REMARKS

Serial No.: 10/667,122
Brake Disk for Vehicles
Greppi, Bruno

Ex. Williams, Thomas J.
Art Unit: 7151
Att. Ref. 60681.300101

FIG. 1

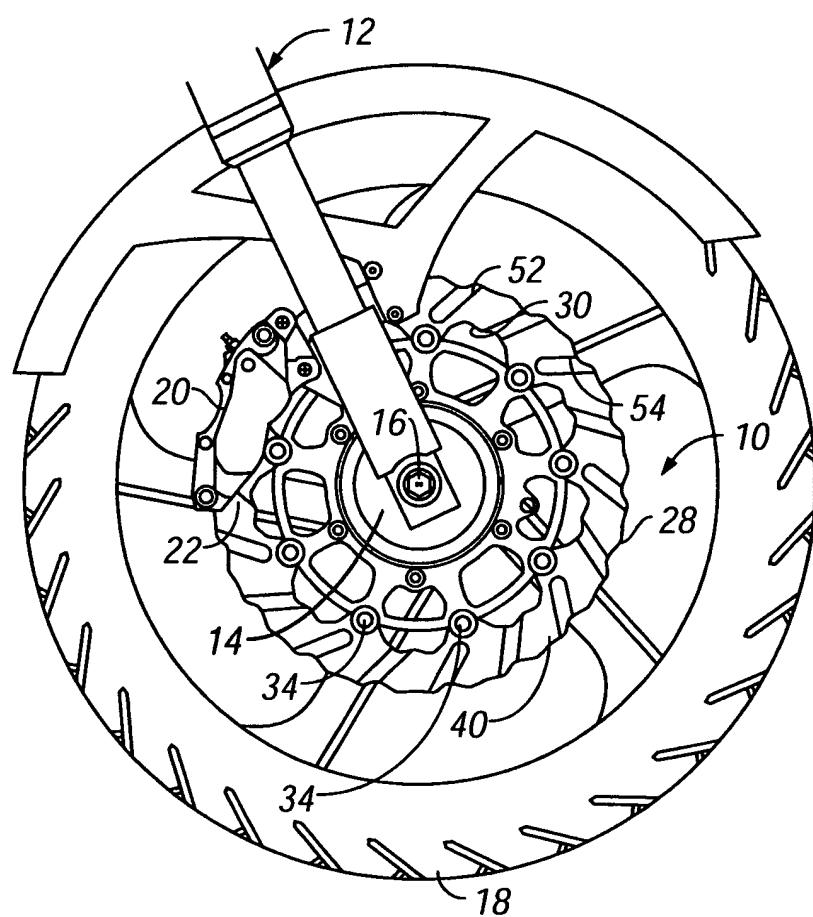
The Examiner, in paragraph 2 objected to the drawings in that reference number 14 was inadvertently omitted from the formal drawings submitted 29 March 2004. Applicant submits herewith, in both redlined and clean versions, new drawing sheets correcting the omission. The correction to Fig. 1 includes element numbering for element 14.

**FIG. 2**

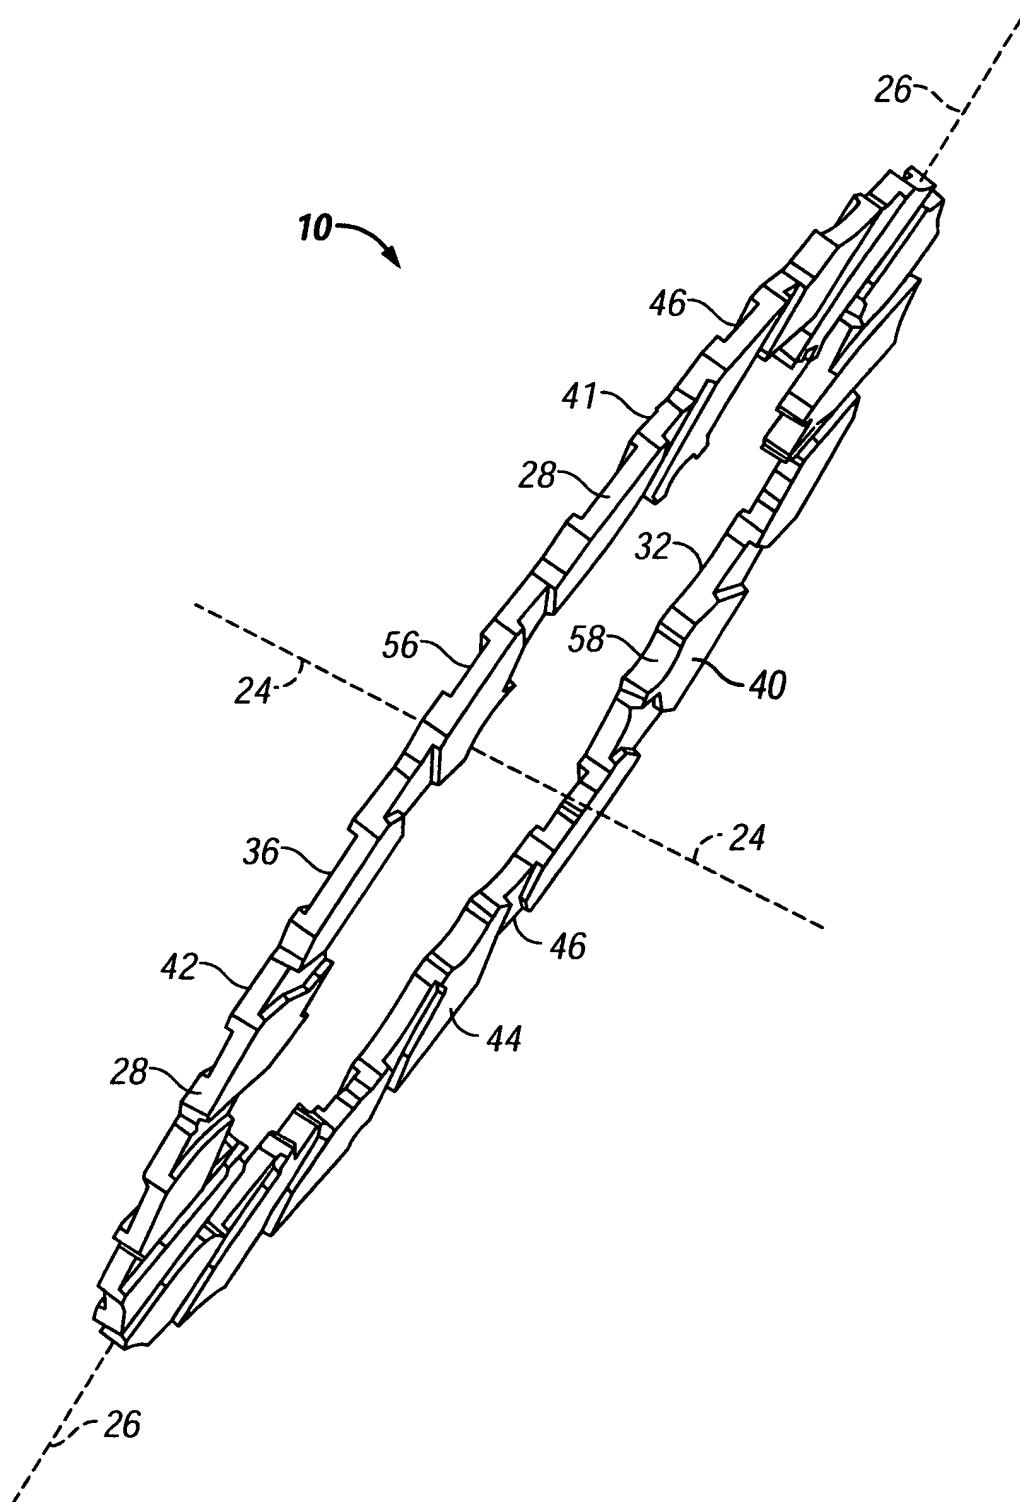
In addition, Applicant has provided correction by adding the global designator 10 to Figs. 2, 3 and 4. Redlined and clean drawing pages are provided for these figures, as well. Although there are no changes to the remaining figures, clean pages are submitted for the entire drawing set.

The Examiner objected to the drawings on the basis of question marks appearing in Fig. 2 in the formal submission. This has been corrected by amending Fig. 2 to replace “??” with 40, (and with the aforementioned correction of changing the global designator from 40 to 10 in the same figure). Redline and clean versions of this are submitted herewith.
